ROCKWALL COUNTY
RFP FOR CONSTRUCTION FOR CRENSHAW ROAD
EAST PROJECT

ADDENDUM NO. 04

TXDOT detail ms-FD-24

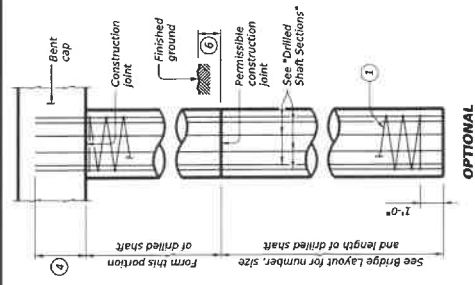
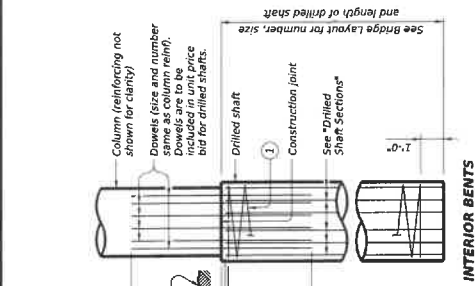
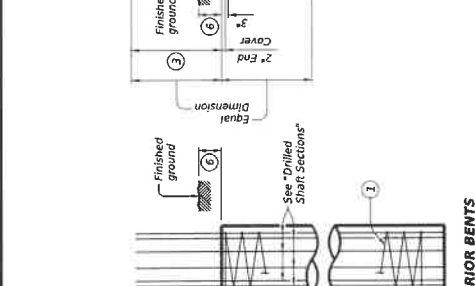
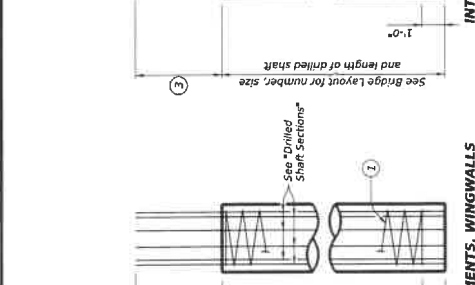
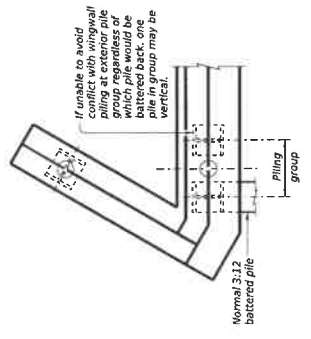
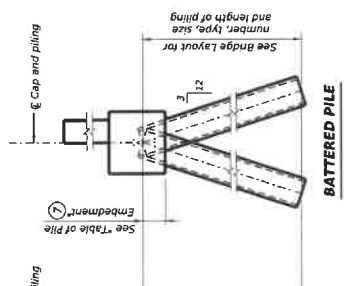
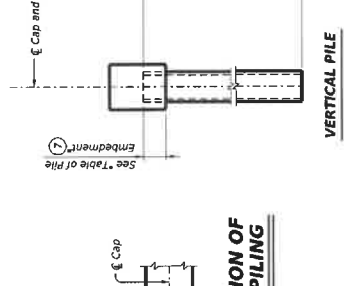
Q9. There is no FD Standard sheet for drill shafts. Will it be added?

A. Yes. TxDOT detail MS-FD-24 will be added to the set.
